June 23, 2023

SUBJECT: Response to *Site Investigation Status Report*
JCI/Tyco FTC PFAS, 2700 Industrial Parkway South, Marinette, WI
BRRTS #02-38-580694

On Apr. 3, 2023, the Wisconsin Department of Natural Resources (DNR) received the *Site Investigation Status Report* (the “SI Status Report”) for the above-referenced site (the “Site”) that was submitted by Arcadis U.S., Inc. (Arcadis), on behalf of Johnson Controls, Inc. and Tyco Fire Products LP (JCI/Tyco). The SI Status Report was accompanied by the fee required under Wisconsin Administrative Code (Wis. Admin. Code) § NR 749.04(1) for DNR review and response.

Figure 1: PFOA Results in Groundwater: Overburden Soils

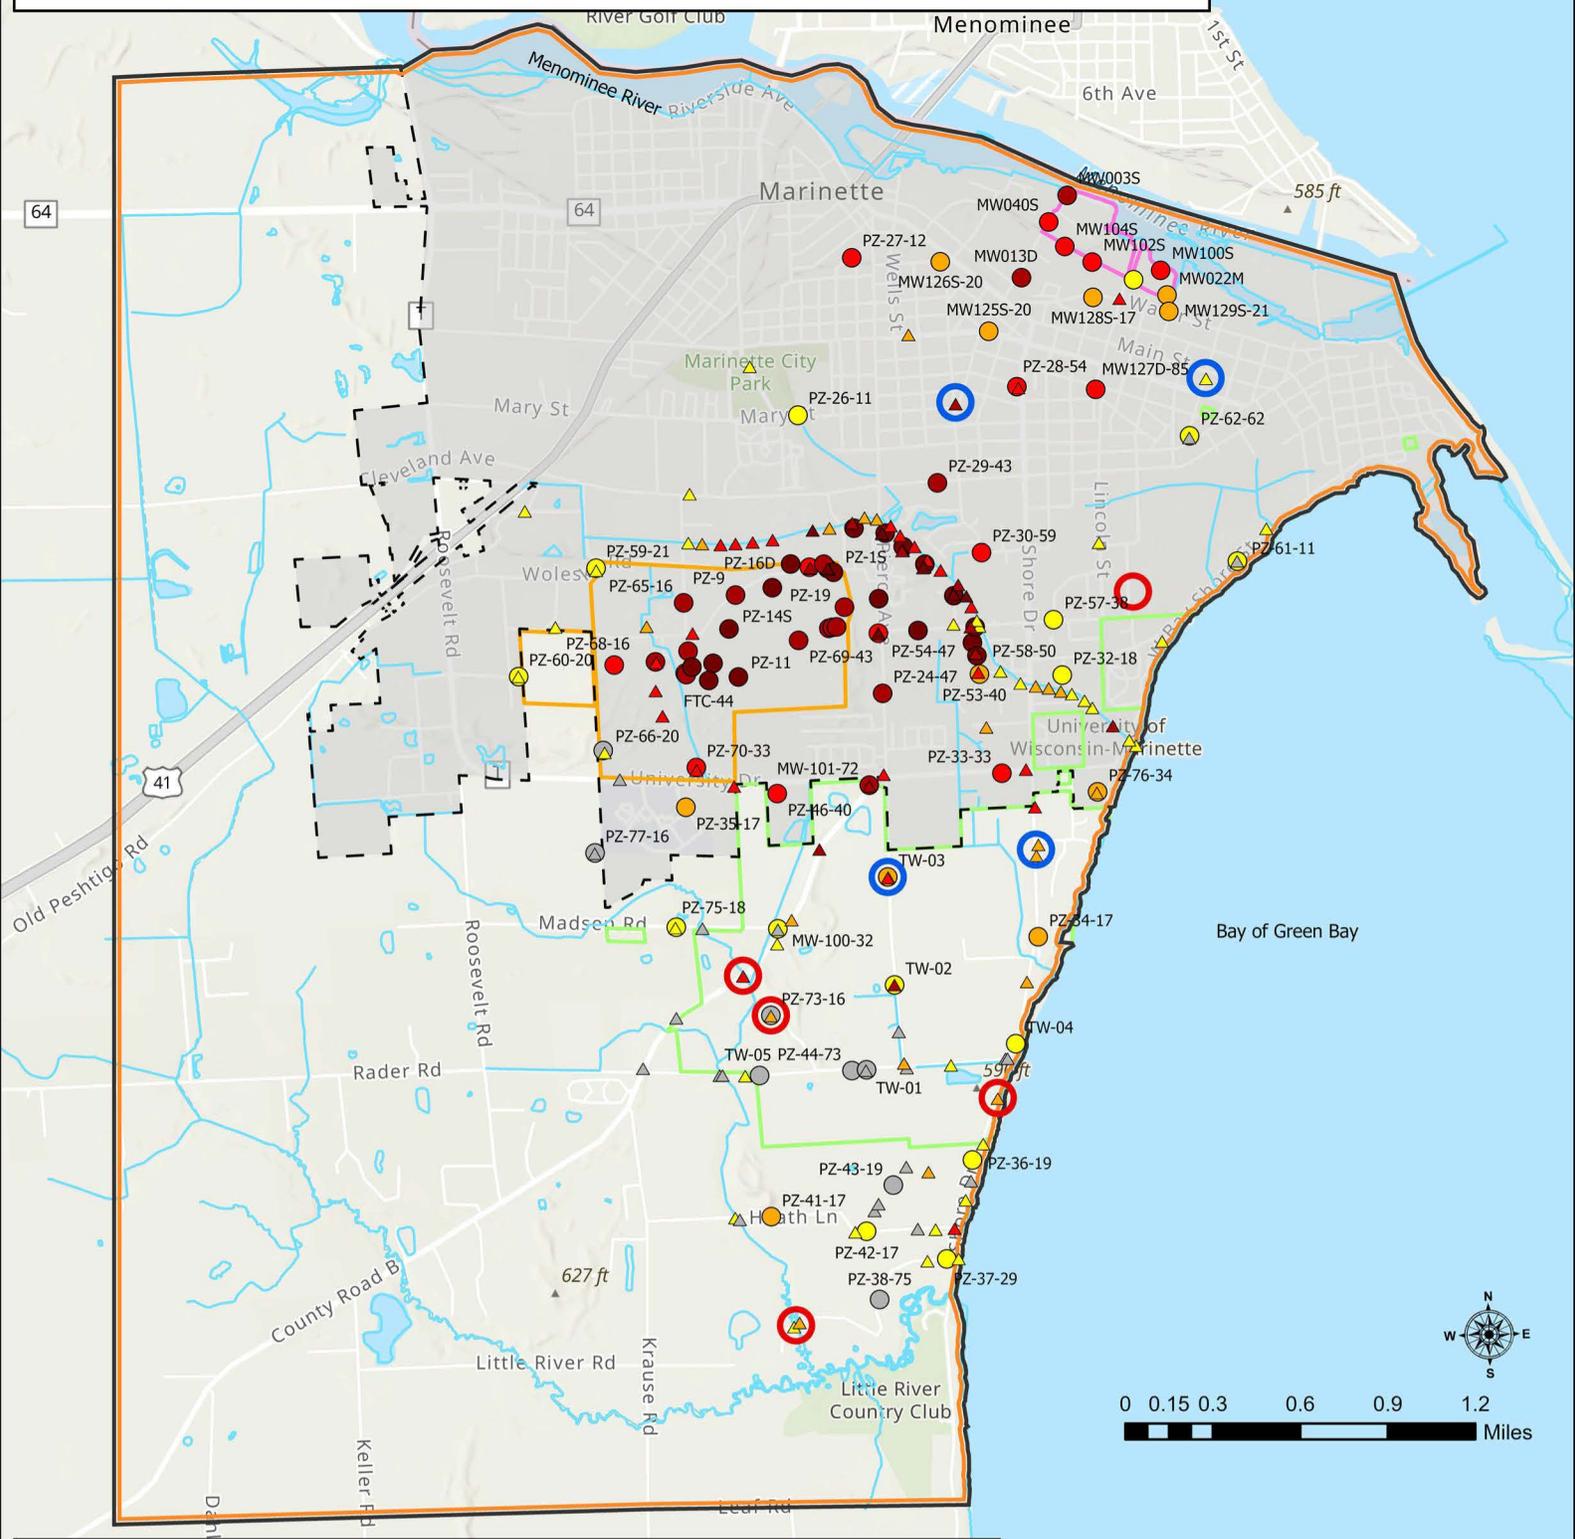
Locations that will require additional data to make progress toward a complete SI are shown on **Figures 1 and 2** and are described below with reference to the figures with the DNR's prior recommendation in **Attachment A**.

- Groundwater East and Below Ditch B: The highest concentrations of PFAS in groundwater are currently found on the FTC property near the outdoor testing area (OTA) and in groundwater flowing toward the east-northeast from the OTA. While a portion of the groundwater is anticipated to be captured by the extraction wells that are part of JCI/Tyco's interim remedial action – the Groundwater Extraction and Treatment System (GETS) – additional monitoring wells are needed to characterize and monitor the groundwater conditions downgradient (east) of Ditch B and vertically below the capture zone of the extraction wells. Groundwater disperses and follows preferential flow paths east of Ditch B, and currently there is not sufficient coverage in the monitoring well network to evaluate the contaminant distribution in the groundwater in this area. This data is needed not only to define the nature, degree and extent of impacts for the SI, but also to evaluate the outcomes and performance of the GETS. The DNR previously suggested location “A.” If JCI/Tyco determined that this location was not suitable for new monitoring wells, new monitoring wells at other locations between piezometers PZ-31 and PZ-61 are necessary for purposes of the SI and to evaluate the efficacy of the GETS. Completing these evaluations will likely require new wells installed at multiple locations and multiple depths where groundwater flow paths are identified in this portion of the Site.

- Groundwater Southeast of FTC: PFAS impacts to groundwater were detected in private wells and samples from VAPs in the area southeast of the FTC. Currently there is not sufficient coverage in the monitoring well network to evaluate the contaminant distribution in the groundwater and contaminant flux to the Bay of Green Bay from this area of the Site. JCI/Tyco has indicated plans for 2023 to install four new monitoring wells at two vertical aquifer profile locations that were completed in 2022; two new wells at VAP-PZ-72 and two new wells at VAP-PZ-74, each to be screened at depths based on the VAP sampling results. The DNR agrees with these four proposed monitoring wells and recommends that JCI/Tyco install additional monitoring wells to evaluate the groundwater plume downgradient (southeast) of VAP-PZ-72. These additional monitoring wells should be screened at depth(s) based on VAP results and the vertical hydraulic gradients measured in the area. The DNR recommends monitoring wells be completed near location “D” and/or near VAP-35 south of Ditch E.

- Groundwater flow paths originating from the entire losing segment of Ditch A south of the FTC: JCI/Tyco's CSM and data collected to date show that Ditch A is a significant historical and current surface water drainage feature in the area that cuts through the FTC property. PFAS contamination reached the ditch through surface runoff and wetland drainage from the FTC. The PFAS impacts in Ditch A can infiltrate into groundwater along the segment of ditch that is a losing stream – a segment that spans over ½-mile as Ditch A flows south from the FTC past Madsen Road. The groundwater flow paths for PFAS that enter the groundwater anywhere along this ½-mile segment differ from the flow paths for PFAS that infiltrate and begin flowing in groundwater from the OTA. The placement of monitoring wells and conclusions on the nature, degree and extent of contamination must consider flow paths originating from the losing segment of Ditch A. A few examples from the DNR's review of the SI Status Report include the following:

- PFOA detected at 194 ppt in the shallow groundwater at VAP-09 is likely to be within the extent of the plume because this location is near the end of the losing segment of Ditch A connected to the FTC. To accurately characterize this area, DNR recommends installing monitoring wells screened at depths where PFAS were detected in VAP-09, which corresponds to location "F."

- PFAS detected in PZ-41, VAP-63 and VAP-PZ-73 are likely to be within the extent of the PFAS impacts from the FTC, because these locations align with groundwater flow paths originating at Ditch A south of Madsen Road. To accurately characterize the aquifer along this groundwater flow path originating from Ditch A, DNR recommends installing monitoring wells screened at depths where PFAS were detected in samples collected from VAP-PZ-73 and VAP-63.

- Surface water in Ditch B at SW-15: The concentrations of PFAS in the surface water in Ditch B near the outlet to the Bay of Green Bay (previous sample location SW-15) remains a data gap in the Site characterization. In the SI Status Report, JCI/Tyco indicated that in spring and summer 2023 it will sample surface water in Ditches A, C, D, and E at the respective outlets to the Bay of Green Bay and the surface water in the Bay of Green Bay (presumably at the six locations shown in Attachment A). The DNR recommends that JCI/Tyco also collect surface water samples at SW-15 during these surface water monitoring events.² The PFAS results from upstream sample location SW-39 are not expected to be representative of the PFAS concentrations in the surface water conditions near the ditch's outlet to the Bay of Green Bay.

Figure 2: PFOA Results in Groundwater: Shallow Weathered Bedrock

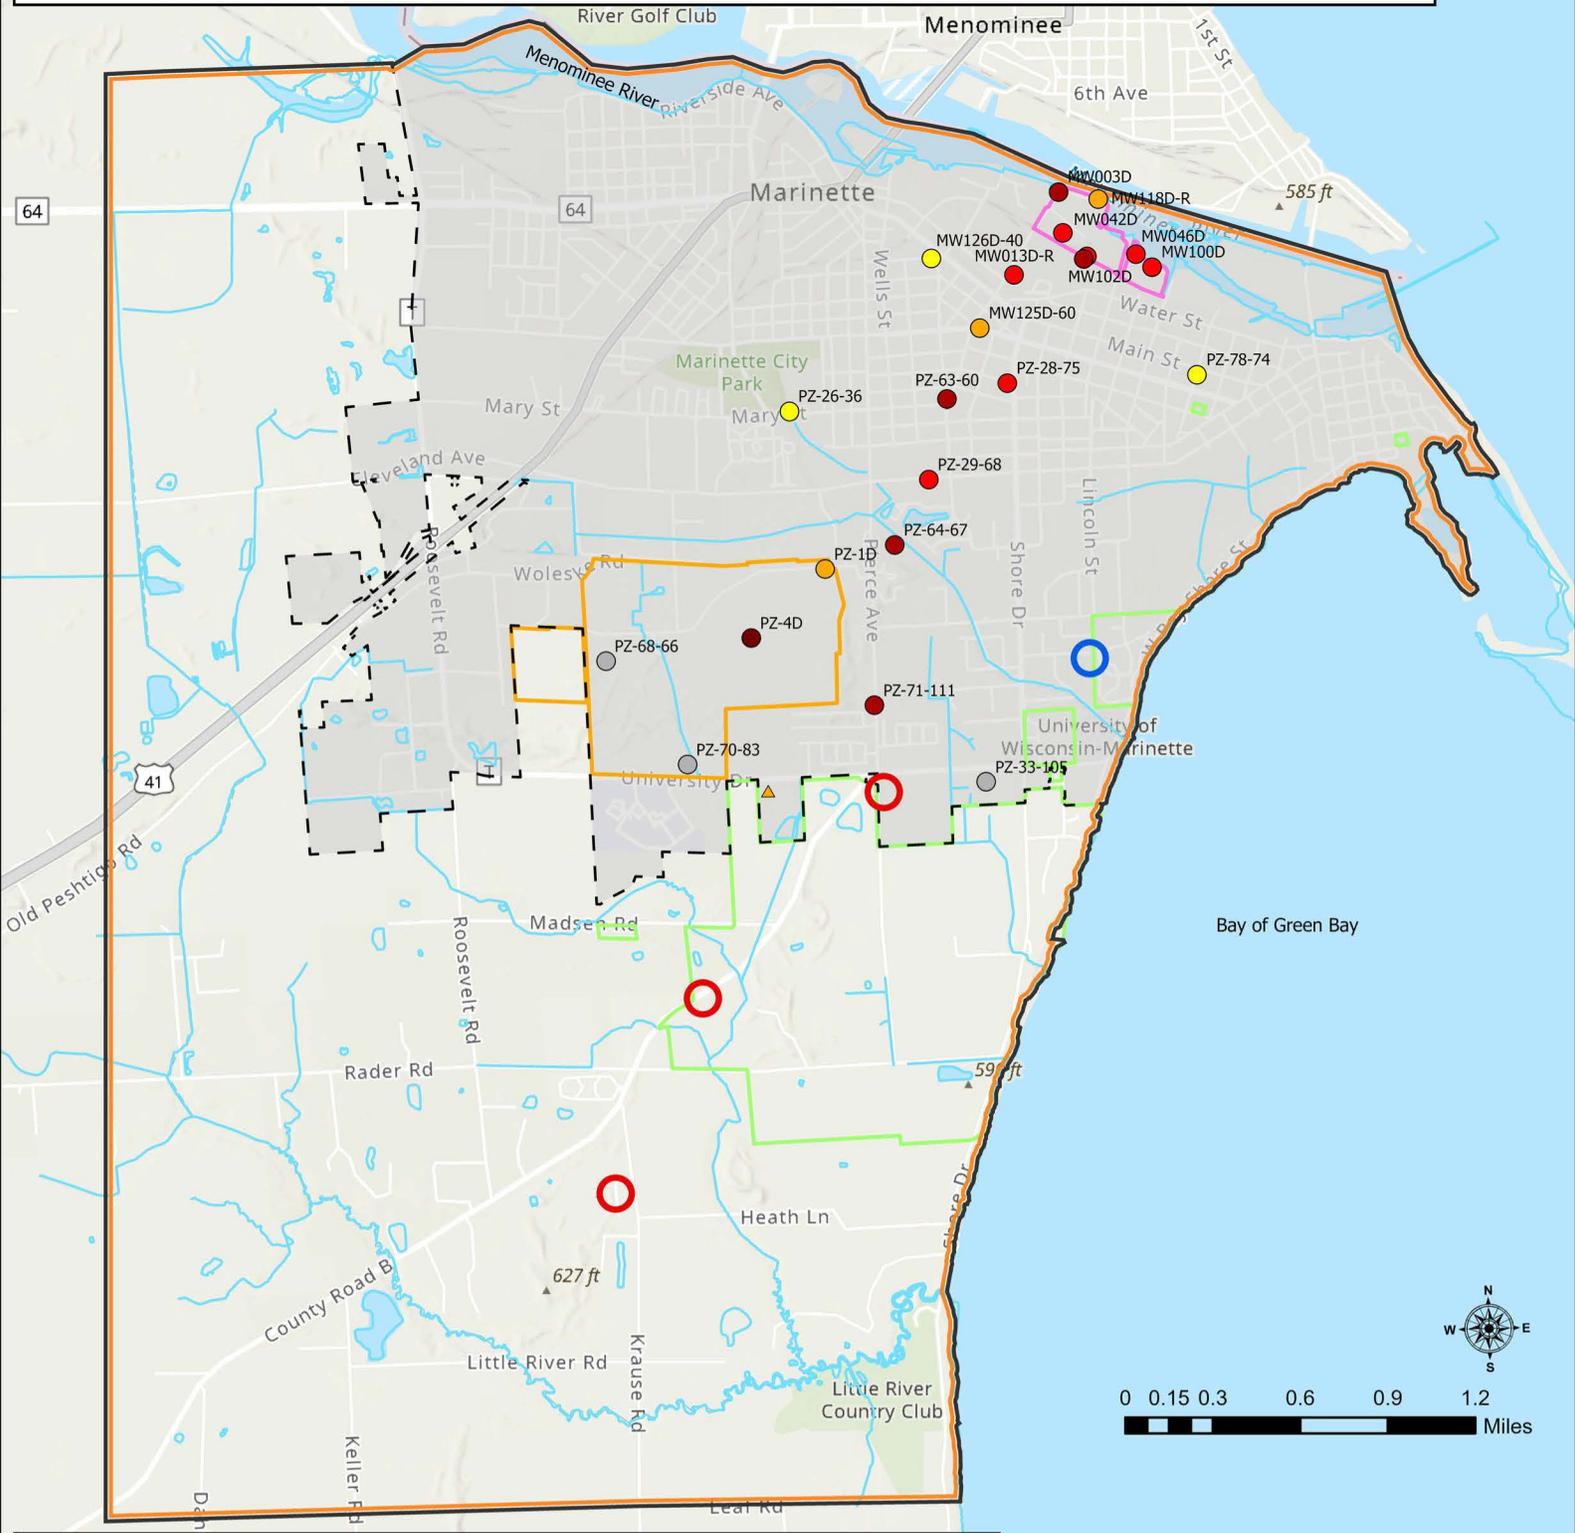
- Weathered bedrock layer following the slope and strike of bedrock south of the FTC: The data in the SI Status Report confirmed that PFAS reached the weathered bedrock in areas where it has hydraulic connection to the overlying unconsolidated aquifer (e.g., natural features or because of poor well construction) and further confirmed that the weathered bedrock is a transport pathway for PFAS migrating east from the FTC. Because groundwater in the unconsolidated aquifer flows radially from northeast and to the south from the FTC, it is reasonable to conclude that a similar flow pattern occurs in the weathered bedrock layer and that there is a southern component of groundwater flow in the weathered bedrock. PFAS in groundwater migrating in weathered bedrock south of the FTC may follow the slope and/or strike of the bedrock surface. Currently, there are not sufficient monitoring wells to evaluate the weathered bedrock layer south of the FTC. Because flow in the weathered bedrock is highly "heterogenous and anisotropic," more than one monitoring well is recommended to evaluate this potential pathway. The DNR previously recommended locations "B," "F" and "G."
